Cambridge City Council
City Clerk, City Hall, Cambridge

June 19, 1994

I am writing to you regarding the reconstruction of Elmer street. This work has been almost equivalent to building a completely new street. The road surface and sub surface are being dug up and replaced. The sidewalks have been removed, new curbstones laid, and new sidewalks poured. The gas main was replaced, and a new drainage system installed.

Hingham st

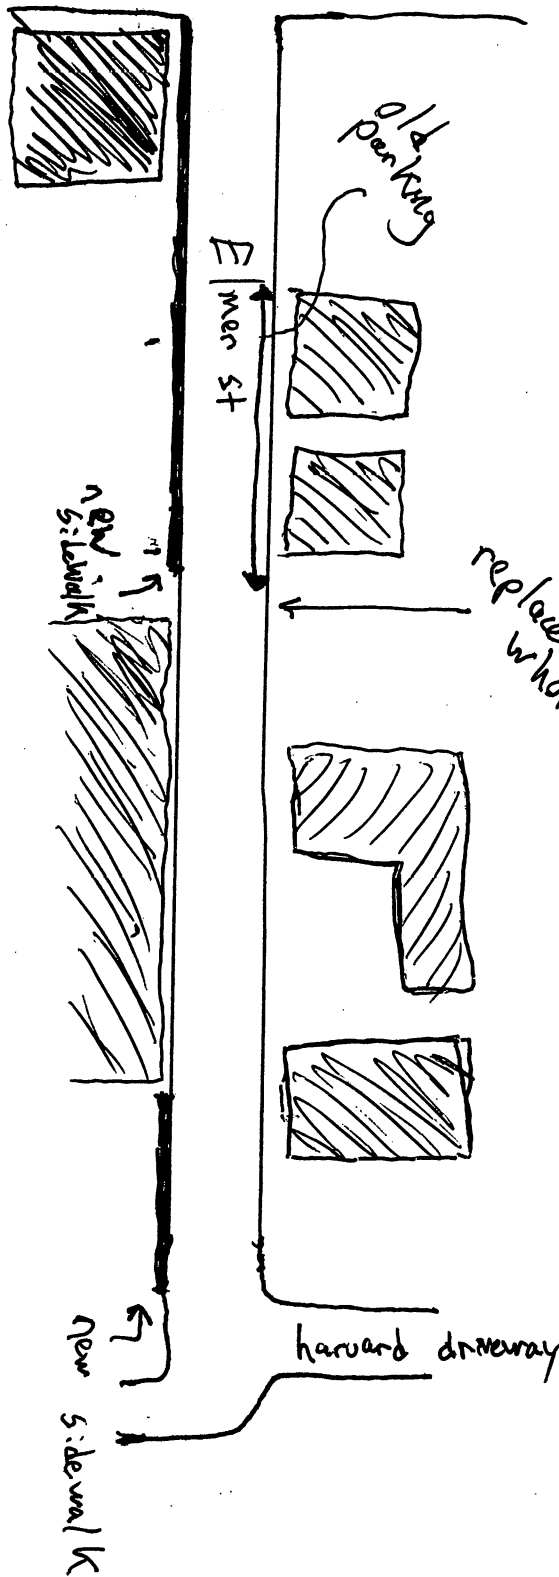
It is a very odd sidewalk. (Please refer to the diagram being submitted separately.) It is an extremely narrow sidewalk, much narrower than a typical sidewalk. The sidewalk is also not very continuous: starting at one end of Elmer street there is about 140 feet of sidewalk, then 130 feet without the sidewalk (due to head-on parking for an apartment building), then another section of sidewalk about 50 feet long. The sidewalk creates a (one-way) street that is 16 feet wide. This is four feet wider than required for a one-way street, but between two and four feet narrower than needed for a one-way street with parking.

We, the residents were never consulted about what would be good for our neighborhood in regards to this work. Now we will have a wide, barren, one way street without parking. The City has spent time and money installing a sidewalk which the neighborhood does not want. I would like at least the section of sidewalk that is blocking our parking removed.

replaced existing sidewalk,
whole length
